**METROPOLITAN GOVERNMENT OF NASHVILLE AND DAVIDSON COUNTY**

**STAFF RECOMMENDATION**  
**1536 Douglas Avenue**  
**January 20, 2016**

**Application:** New construction – addition; Partial demolition  
**District:** Eastwood Neighborhood Conservation Zoning Overlay  
**Council District:** 6  
**Map and Parcel Number:** 08302019700  
**Applicant:** John TeSelle, AIA  
**Project Lead:** Melissa Sajid, [Melissa.sajid@nashville.gov](mailto:Melissa.sajid@nashville.gov)

**Description of Project:** This application is to demolish a non-contributing addition and to add an eight hundred and thirty square foot (830 sq. ft.) one-story rear addition.

SITE PLAN

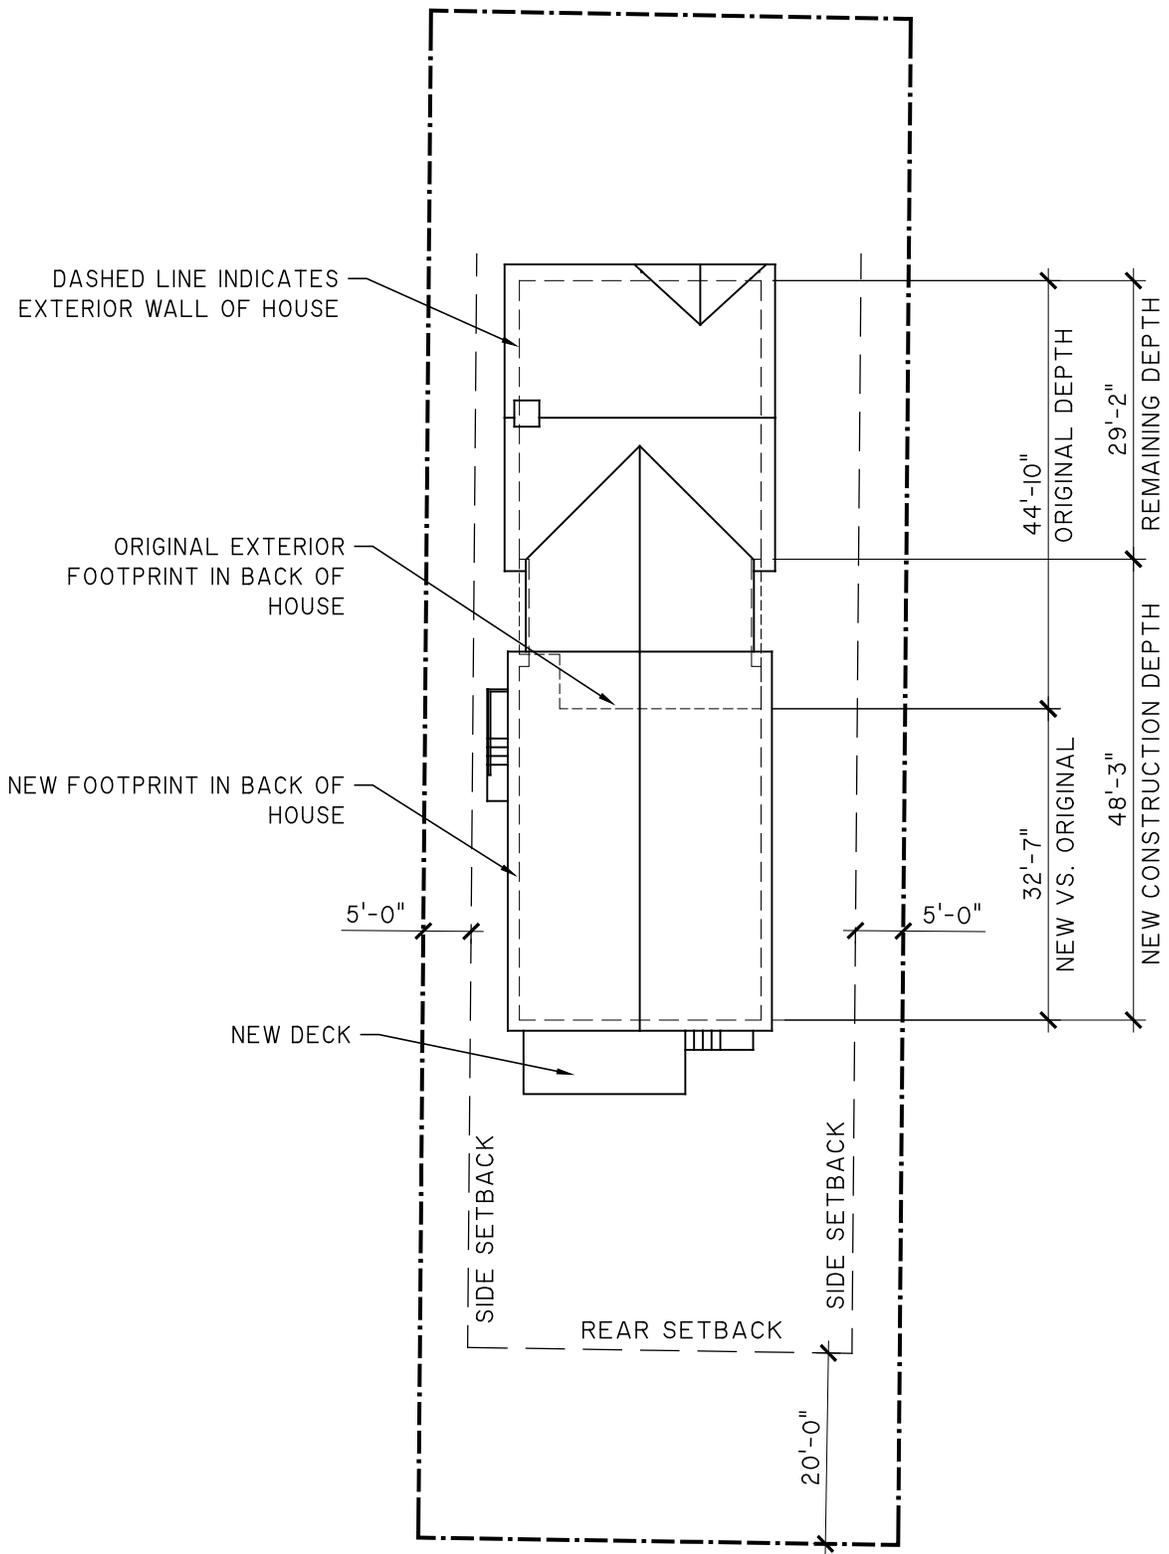
Setback: The setbacks will be thirteen feet (13') on the left side, and seven feet (7') on the right side. The rear wall of the addition will be forty-five feet (45') from the rear property line. The setbacks for the addition meet the bulk zoning standards and are consistent with the historic context of the surrounding area. Therefore, staff finds that the project meets section II.B.i.c for setbacks.

A2.5

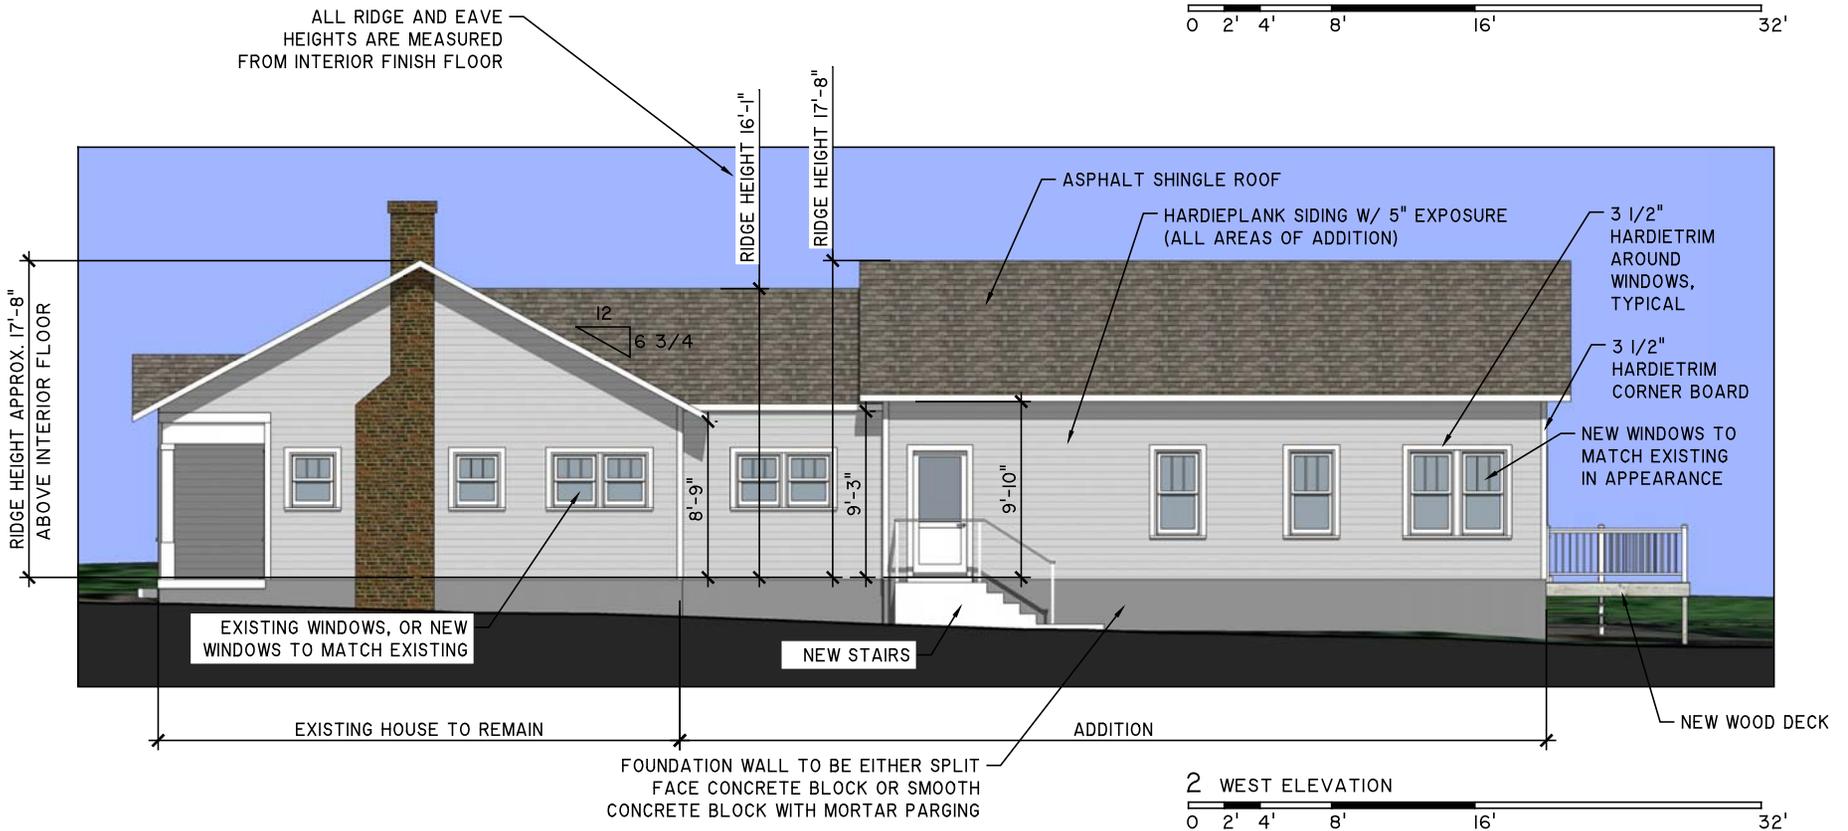
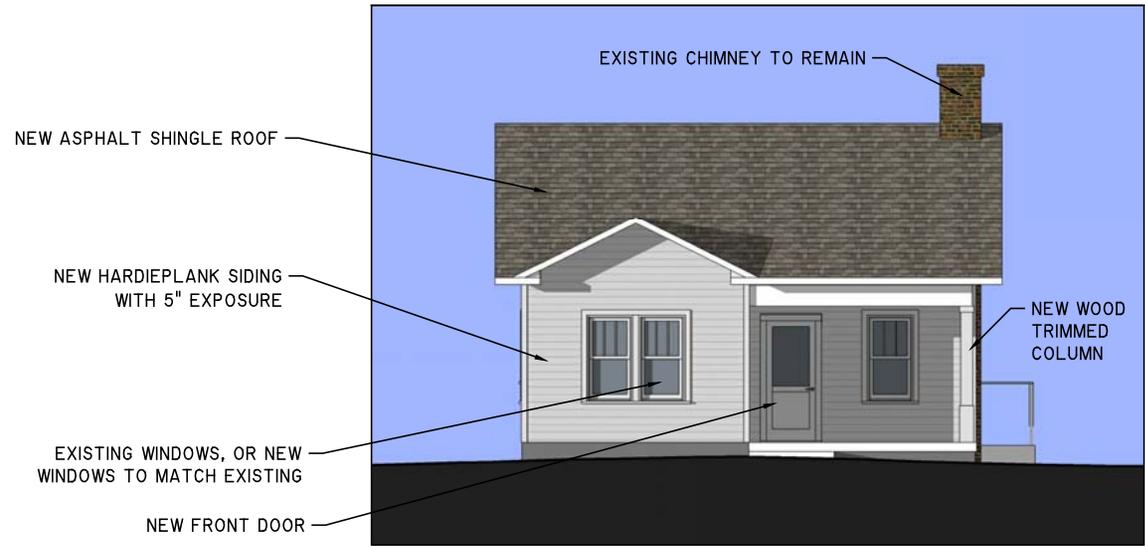
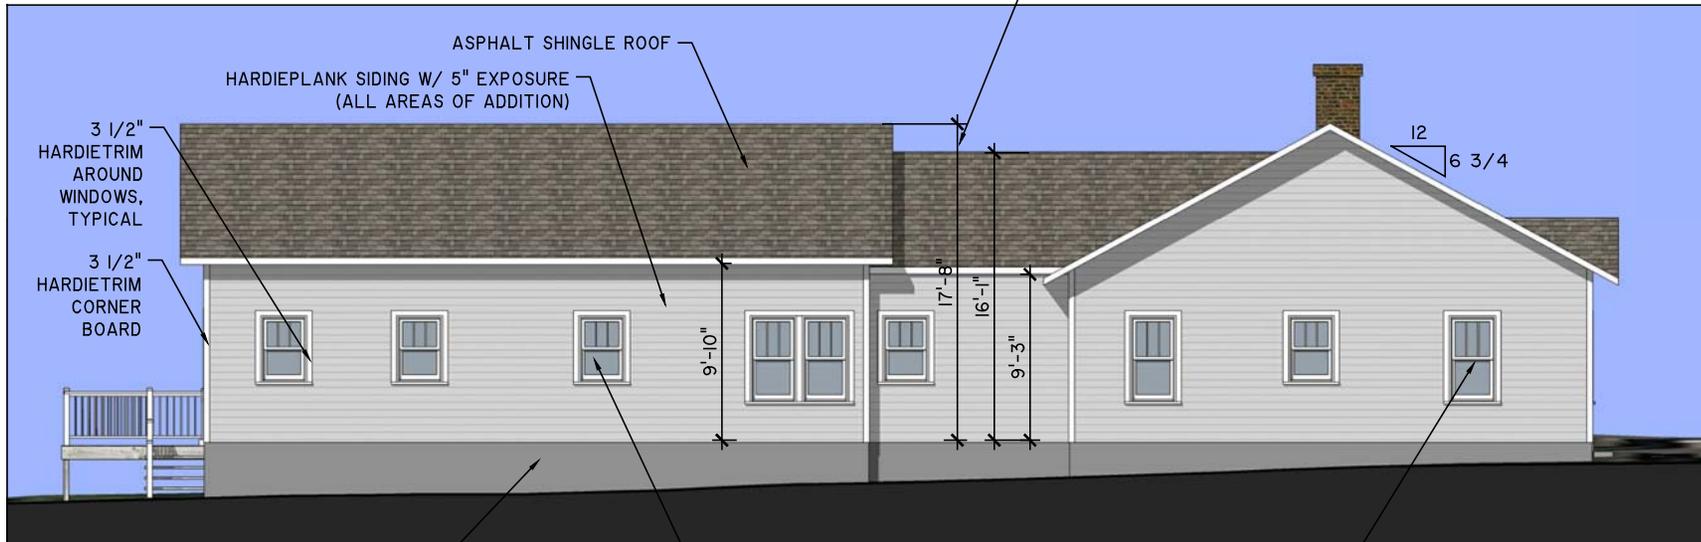
Height & Scale: The addition has a maximum ridge height that is the same as the ridge height of the historic house, and the maximum foundation height is approximately three feet, six inches (3' 6") at the rear of the addition as the property slopes down toward the rear of the property. Eave height on the addition is similar to that on the existing house.

Materials: The cladding on the addition will be Hardie plank siding with a 5" reveal to match the siding proposed for the historic house, and the trim will be Hardie trim. The roof will be asphalt shingles for the addition and the historic house, and the foundation will be either a parged or split face concrete block foundation. Details have not been provided on the materials for the windows, doors, and roof color as well as the side entrance and rear deck landing, decking, and railings. Staff recommends including a condition that staff approve the final window and door selections prior to purchase and installation and that staff approve the roof color and materials for the side entrance and rear deck landing, decking, and railings. The known materials meet the design guidelines and have been previously approved by the Commission. With the condition that staff approve the final selection of the unknown materials specified above, staff finds that the project meets section II.B.1.d.

Roof form: The roof form of the addition is cross-gabled, with roof pitches that complement the existing historic house. The roof form and pitch does not contrast with those of neighboring historic buildings and are compatible with the roof form of the historic house. The project meets section II.B.1.e.

Proportion and Rhythm of Openings: The windows on the proposed addition meet the historic proportion of openings, being generally twice as tall as they are wide. There are no large expanses of wall space without a window or door opening. Staff finds the project's proportion and rhythm of openings is consistent with Section II.B.1.g.

1. Staff approve the final details, dimensions and materials of windows and doors prior to purchase and installation.
2. Staff approve the roof color and materials for the side entrance and rear deck landing, decking, and railing prior to purchase and installation.
3. The original window casings and the three front three-over-one historic windows shall be retained.
4. If utilities are added or relocated, they shall be located on the rear façade or on a side façade beyond the midpoint of the house.
